Field Service Bulletin No. 23

ADC Solo
Type 5155 / 100

Path Speed CR SP1001
Type 5155 / 200

Errors due to defective R/F tag reader

Figure 1

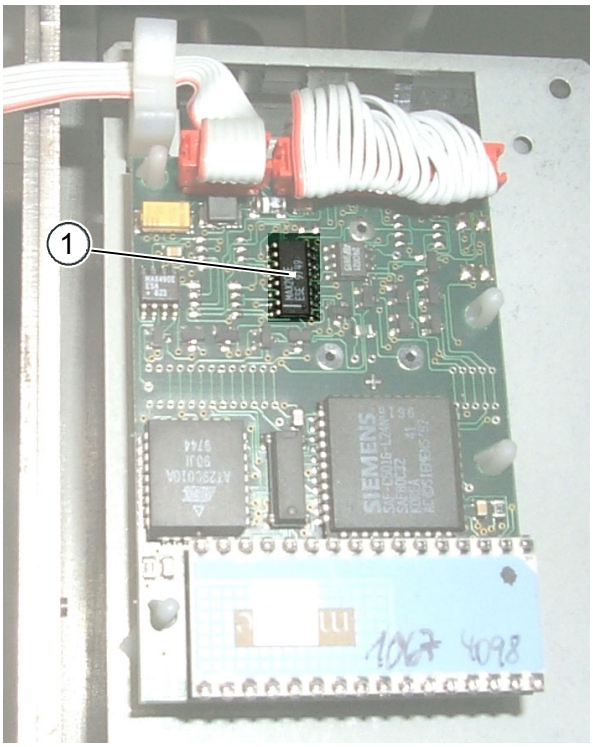
The tag reader does not work correctly due to a defective chip (named with Δ00036) on the board **(see Figure 1).**

- the chip (1) has the imprint **Δ00036**.

Exchange the tag reader

The tag readers on stock have a new chip included.
The spare part number stays: **CM+9.5155.5135.0**.
